# UNITED STATES PATENT AND TRADEMARK OFFICE

APPLICATION NO.	FILING DATE	FIRST NAMED INVENTOR	ATTORNEY DOCKET NO.	CONFIRMATION NO.
10/521,992	09/27/2005	Horst Zeiser	18513	1755
272 7590 08/06/2008 SCULLY, SCOTT, MURPHY & PRESSER, P.C. 400 GARDEN CITY PLAZA SUITE 300 GARDEN CITY, NY 11530				
EXAMINER				
KASTURE, DNYANESH G				
ART UNIT		PAPER NUMBER		
3746				
MAIL DATE		DELIVERY MODE		
08/06/2008		PAPER

### Office Action Summary

## **DETAILED ACTION**

FIG. 7

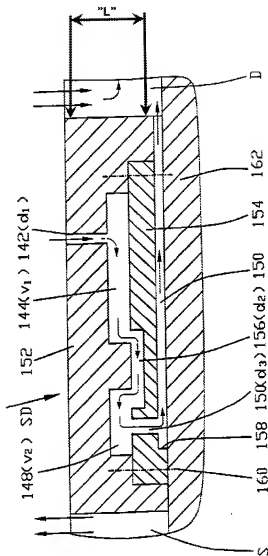
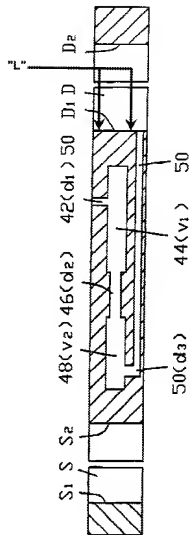
10. In Re claim 1, with reference to Figures 6 and 7 depicted above, Perstnev et al discloses a Piston machine (Abstract: "...hydraulic axial pump/motor...") comprising:

- a rotatably mounted cylindrical drum (26), disposed in which is a plurality of cylindrical bores (C1, C2), which are distributed over the circumference and in which displaceable pistons (P1, P2) are disposed, wherein the cylindrical bores at one side have cylindrical openings, which in accordance with the angle of rotation of the cylindrical drum are temporarily in communication in each case with one of two kidney-shaped control ports (S, D), which are connected in each case to a working line ("L", 14, 16), wherein between the kidney-shaped control ports in each case a switchover region (SD, DS) is formed and wherein;

- a first end (42 or 142) of a pressure compensation line (50 or 150) opens out at least into one switchover region (SD), characterized in that a second end (see end of line 50 or 150 depicted above) of the pressure compensation line opens into the outlet-side working line (D1, D2, 16, "L", also Column 1, Lines 32-37 state: "A tortuous passage of a non-uniform cross-section is formed in the bridging portion, allowing the by-passing of the fluid first in a direction towards the downstream side of the suction port and then towards and into the upstream side of the discharge port");

- "wherein the length (L) of the outlet-side working line between the outlet-side kidney-shaped control port and the second end of the pressure compensation line is so dimensioned that there is a defined phase relationship between a pressure wave, which is caused by a reciprocating motion of the pistons and advances in the outlet-side working line, at the point of the second end of the pressure compensation line and the angle of rotation of the cylindrical drum": As mentioned before, there is always a phase

relationship between the waveform and the angle of rotation at any point along the working line.

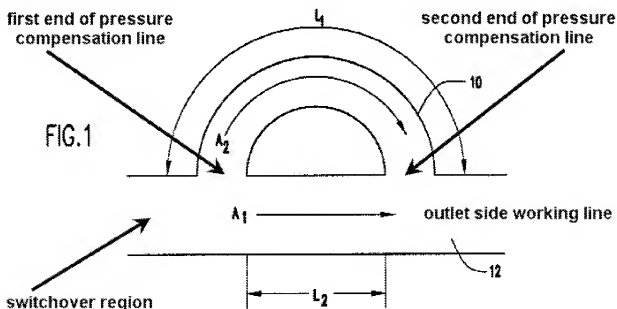
14. Nevertheless, with reference to Figure 1 depicted above, Burdisso et al discloses a Herschel-Quincke tube arrangement where a Pressure Compensation Line (10) has its second end connected to the outlet side working line (12), and its first end originating upstream as depicted, where the length (L1 and L2) is so designed that the sound propagating through L1 cancels the sound propagating through L2 over a range of frequencies as stated in Column 5, Lines 18-22.

15. It would have been obvious to a person having ordinary skill in the art at the time of the invention to modify the tortuous passage of Perstnev et al so it intersects the working line external to the kidney shaped control port (L2 is related to "L" as defined by applicant) for the purpose of reducing noise even if there is a lack of symmetry in the noise field as stated by Burdisso et al in Column 3, Lines 15- 20 (Perstnev et al discloses in Column 1, Lines 19-21: "The object of the present invention is to improve the achievement of noise reduction..").

Fig. 7

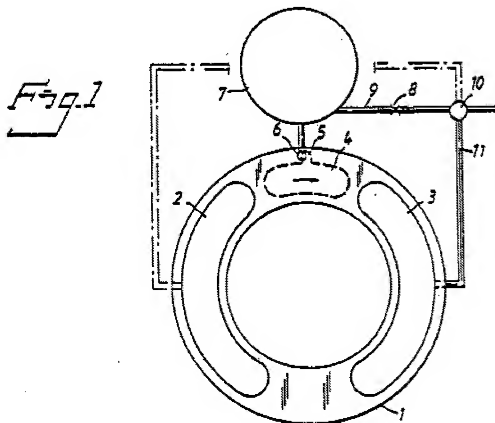
30. Nevertheless, with reference to Figure 7, Nishikawa et al discloses four different tubes with different lengths depending on the phase difference between the gases being transmitted by them so that they arrive opposed to each other Paragraph – [0052].

31. It would have been obvious to a person having ordinary skill in the art at the time of the invention to correct the length of passage of Perstnev et al in accordance with the phase of the gas being transmitted by it as taught by Nishikawa et al so that vibration or noise of the compressor can be excellently decreased as stated by Nishikawa et al in Paragraph [0055]
